MJ11-A

MJ11
MEMORY TIMING AND CONTROL
FCO Cross Reference

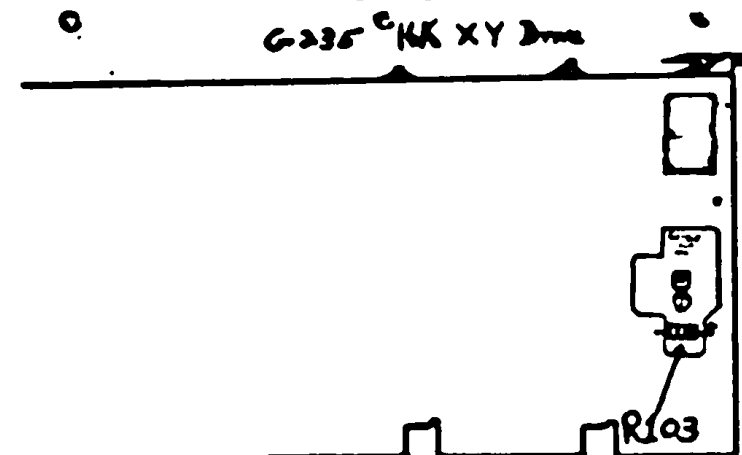
Many reports have been received from the field concerning memories failing high current margins and module set incompatibility (i.e. unable to swap modules). Investigation has shown that the inhibit margins are not properly centered, which could cause marginal operation of the memory under conditions of high drive currents. An ECD (G235-0009) was generated to correct this problem.

1. Place G235 component side up and fingers toward you.
2. Look at right hand side of module in large etch area (see drawing).
3. If resistor R103 (750 1W) which is across bottom of large etch is not in, ECD has not been installed.

This ECD should be installed before attempting massive module swap or option swap.

D-TD-MM1E-08

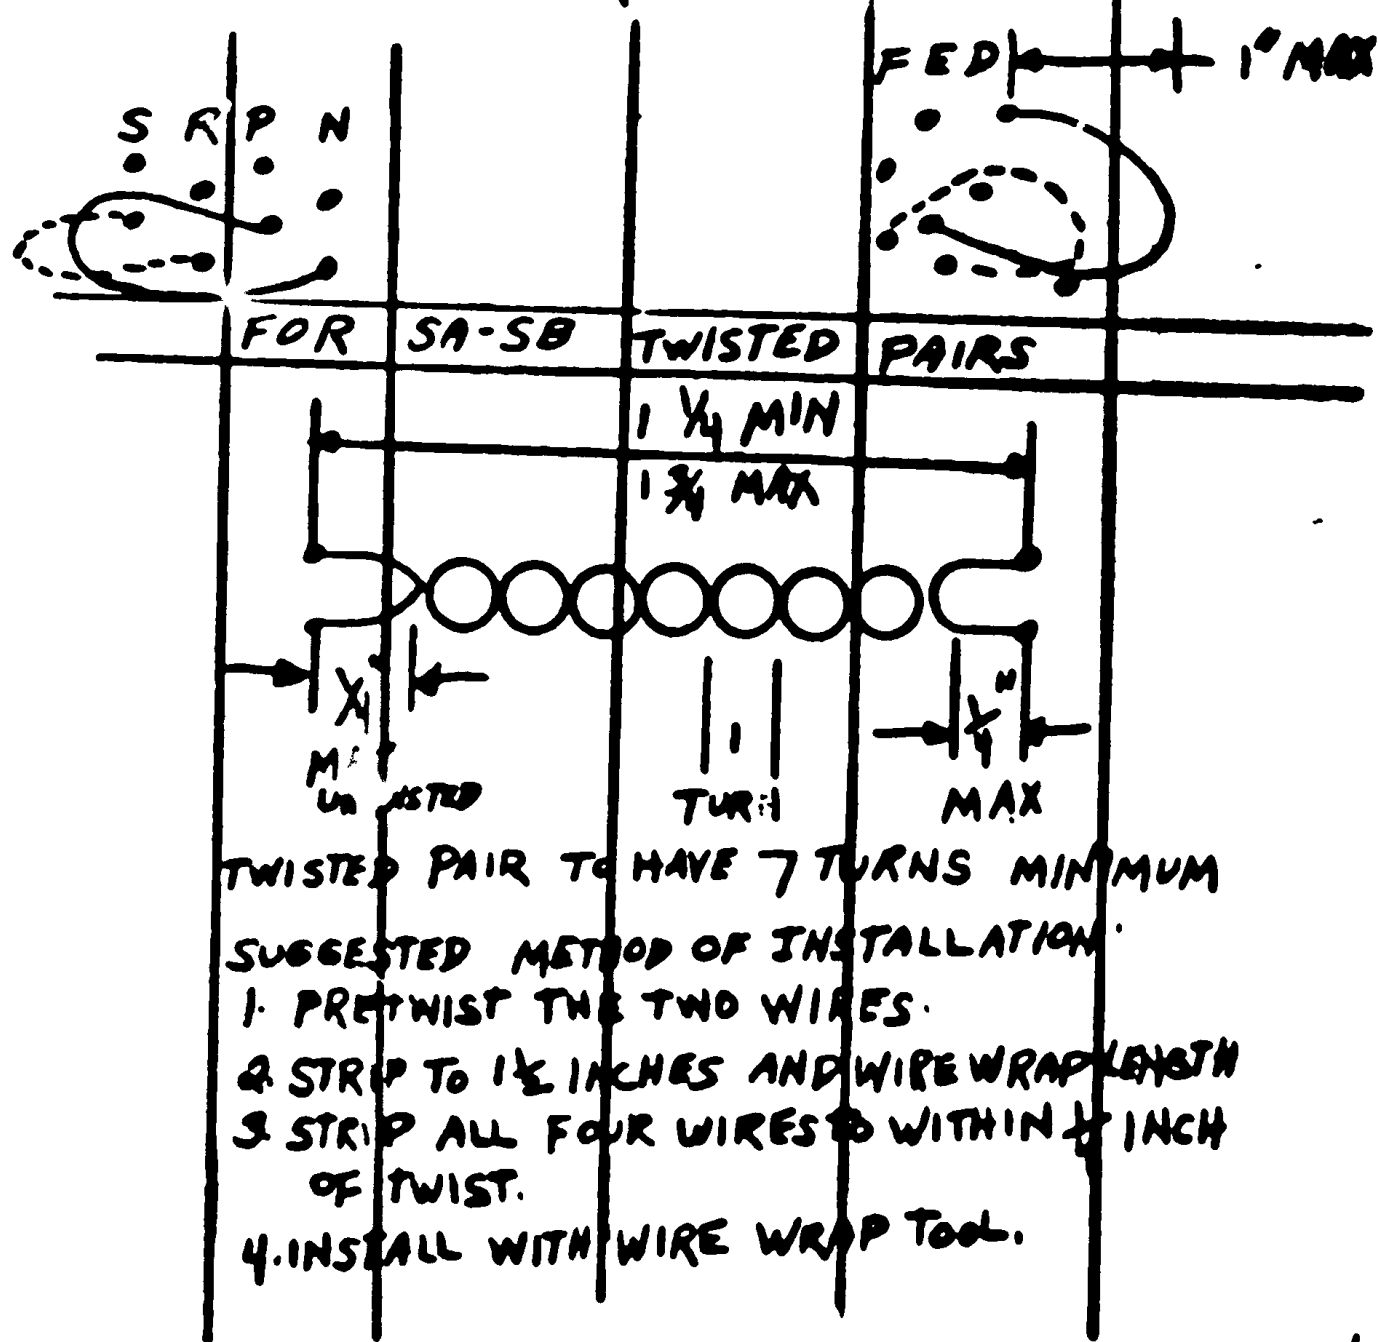
LENGTH SHOULD BE A MAXIMUM OF 2 1/4 INCHES. CHECK DRAWINGS FOR LENGTH AND FOR HOW LOOPS SHOULD BE DRESSED INTO LOGIC.

0-BS-MM11-E-05

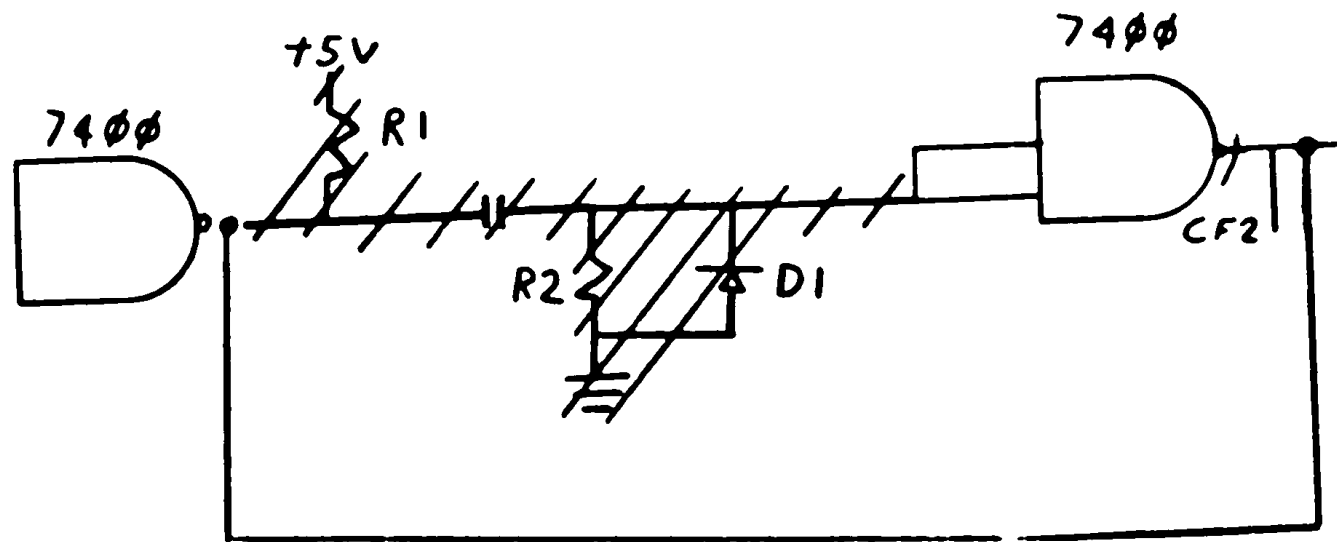
1. CHANGE TEST PROCEDURE TO IMPROVE MEMORY PERFORMANCE.
2. CORRECT WIRE LIST ACCORDING TO SUBMITTED ADD/DELETE SHEET.
3. UPDATE BLOCK SCHEMATIC PER ATTACHED MARKED UP PRINT.
4. UPDATE TIMING AND FLOW DIAGRAM AS INDICATED.
5. REMOVE WRITING FROM MARGIN.

ITEM	PART NO.	OLD REV	NEW REV	(PART NAME) DESCRIPTION OF CHANGE	DISP CODE
1	A-NL-MM11-E	P	R	(MASTER LIST) UPDATE REVISION LEVEL ON THE FOLLOWING DRAWINGS: D-BS-MM11-E-05 FROM A TO B K-WL-MM11-E-07 FROM C TO D D-TD-MM11-E-08 FROM B TO C A-SP-MM11-E-11 FROM O TO A	06
2	D-BS-MM11-E-05	A	B	(BLOCK SCHEMATIC) SEE MARKED PRINT THIS ECO.	06
3	K-WL-MM11-E-07	C	D	(WIRE LIST) SEE ADD/DELETE SHEET THIS ECO.	06
4	D-TD-MM11-E-08	B	C	(TIMING DIAGRAM) DELETE CHECK RACE COND. IN MARGIN. INCREASE TIME AND FLOW IN DISZ BEFORE 650NS. INCREASE TIME AND FLOW IN CINE BEFORE 350 NS.	06
5	A-SP-MM11-E-11	-	A	(ENGINEERING SPECIFICATION) DELETE FROM PARA. 11.0 210 NS . ADD 220NS. ADD TO PARA. 13.4- IF THE MARGIN IS GREATER THAN 1.0V SET VKY AT 0.5 BELOW THE FAILING HIGH END POINT. (EXAMPLE IF MARGINS ARE 0.4 TO 1.0V, SET AT 1.3V= 1.0-0.5)	06

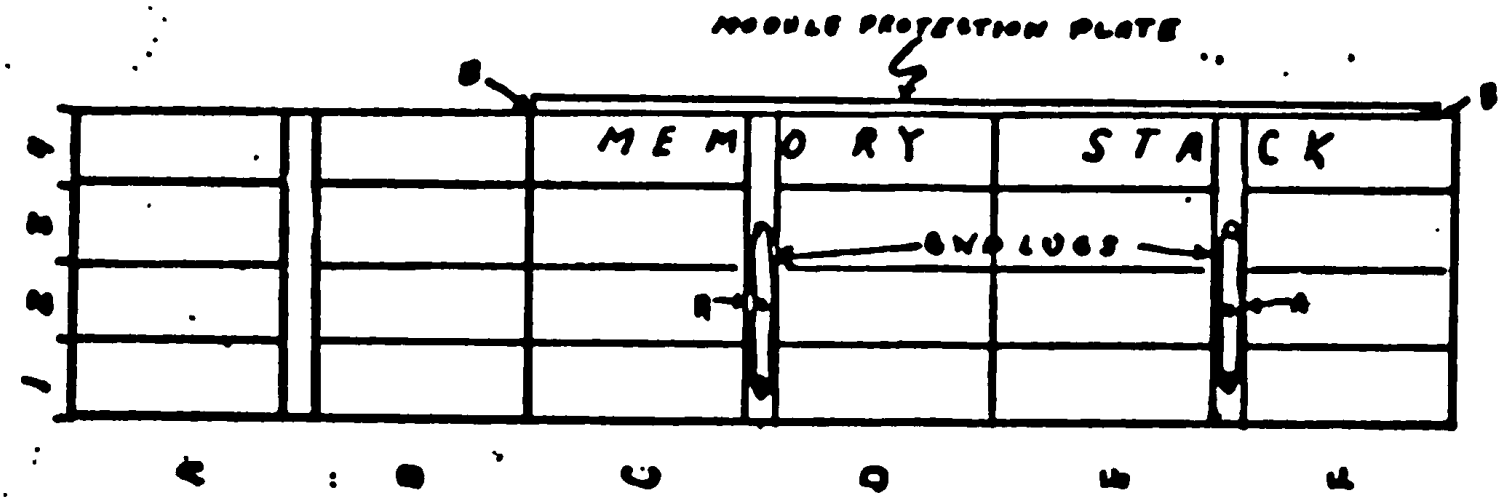
- Carefully install module protection plate per FCO instructions. This requires insertion of the plate under existing wire runs which are easily broken.
- Run maindeck or other programs whose failure indicated the need for this FCO to be implemented. They should now function correctly.

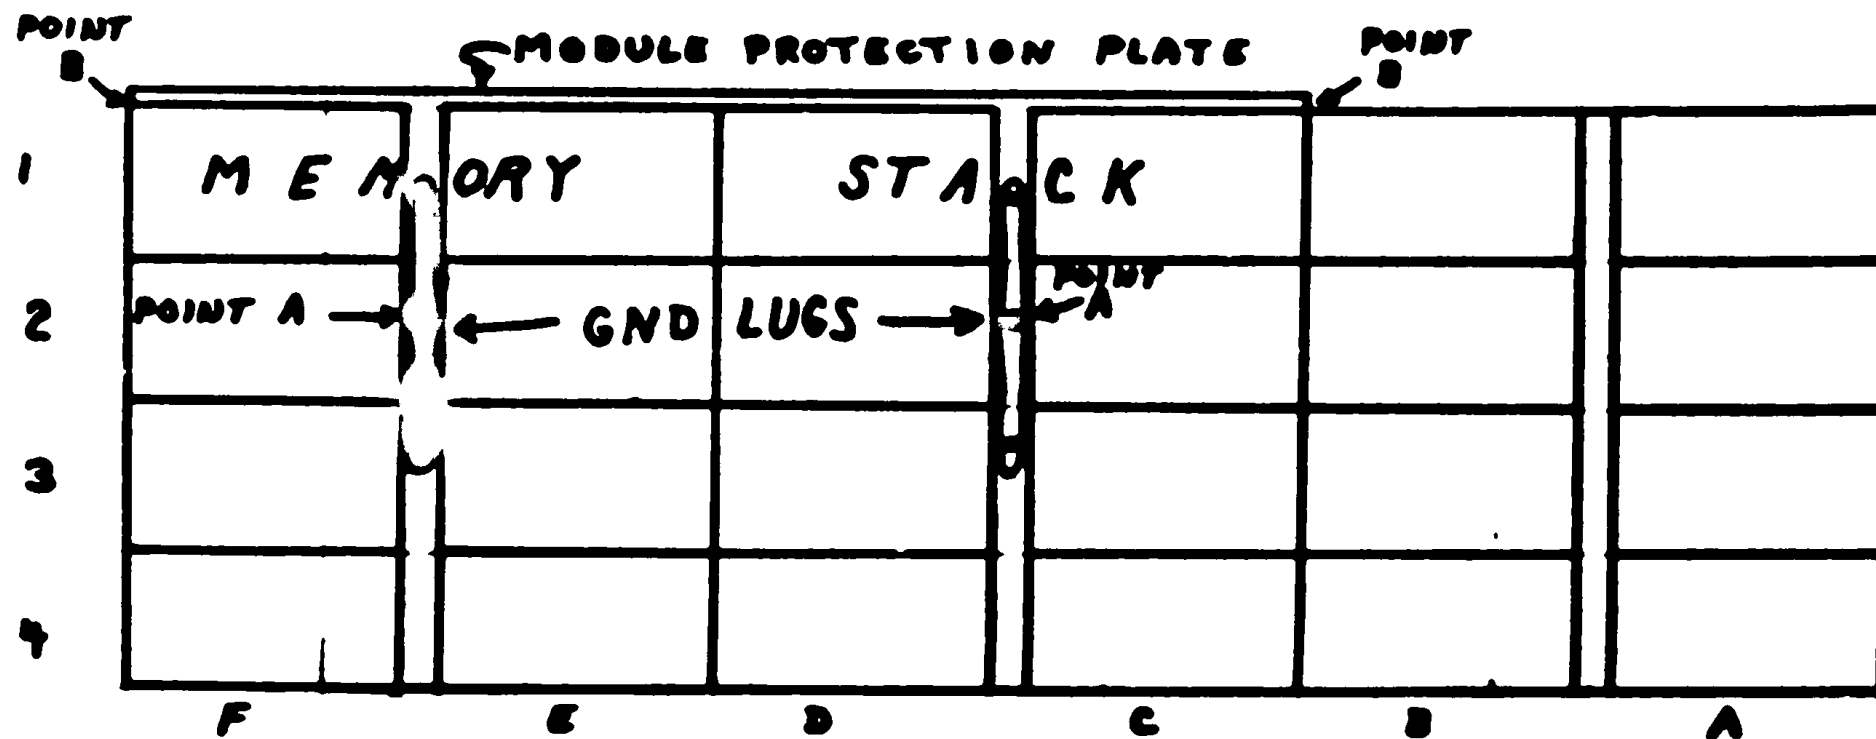
NOTE This FCO is required when other options such as KW11-P, etc. are physically mounted next to an MM11-S memory. Noise generated by the MM11-S may interact with adjacent modules.
